CITY OF SOMERVILLE, MASSACHUSETTS  
OFFICE OF STRATEGIC PLANNING & COMMUNITY DEVELOPMENT  
JOSEPH A. CURTATONE  
MAYOR

**ALTERATION TO A HISTORIC PROPERTY STAFF REPORT**

Site: 16 Westwood Road c.1911  
Case: HPC 2015.007 Westwood Road Local Historic District

Date of Application: February 25, 2015  
Legal Notice: *Reconstruct widows walk, replace dormer windows, and alter front porch railings and posts.*

16 Westwood Road 2009

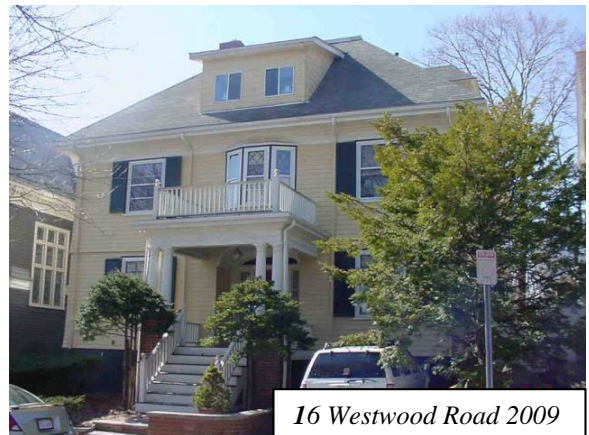
Jerkin headed dormers are located on the sites of the hipped roof. A flat roof dormer was added circa 1968 and at some point the original widows walk was removed.

The dormer may have been constructed in 1968 per Building Permit records. It currently has 2 small casement windows that are both ill-proportioned and not compatible with the style of the house.

There is no widows walk. The current railings and posts are generic.

1. The widow's walk shall be constructed *with the proportions and style shown in the historic photograph*;
2. Staff and a Commission Member shall confirm that the posts are similar in style and proportion to the photograph prior to installation.
3. The balustrade on top of the front entry porch, the rails, balusters and posts of the front porch and stairs shall match those of the widows walk.
4. The windows in the third floor dormer shall be double-hung single diamond light upper sash and single light on the lower sash.

Similar window and baluster from a circa 1920 catalog

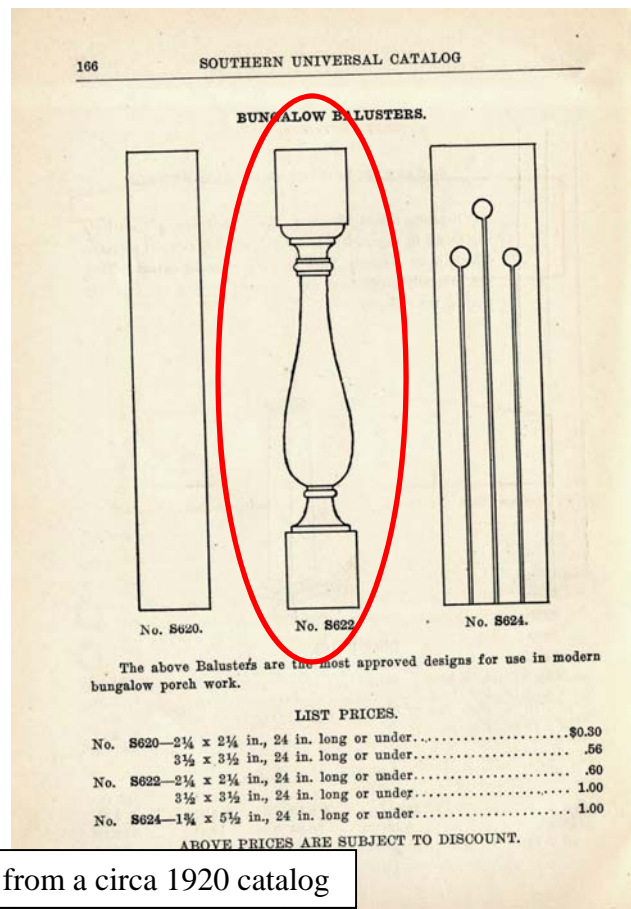
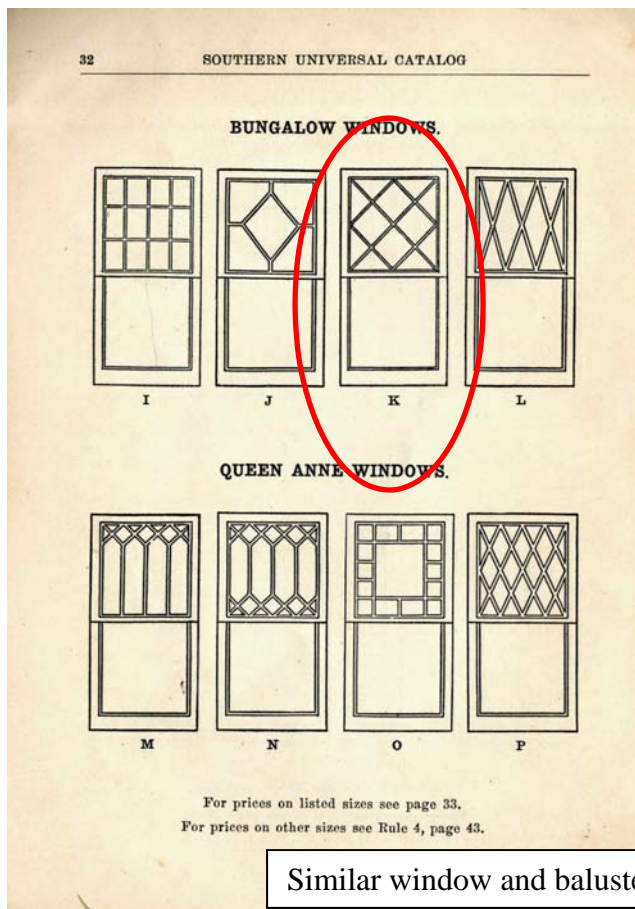
The dormers on the side of the building are narrower than the front dormer and have double-hung windows. The proposal is to replace the sliding windows with double-hung windows on the front dormer with diamond patterned upper sash to match the existing sash in center bay on the second floor. This was reviewed and approved by the Commission back in 1988, however, the details of the approved windows were not in the files but appears to have been double-hung sash.

The windows will also be double-hung wood sash with a diamond pane configuration similar to that of the second floor.
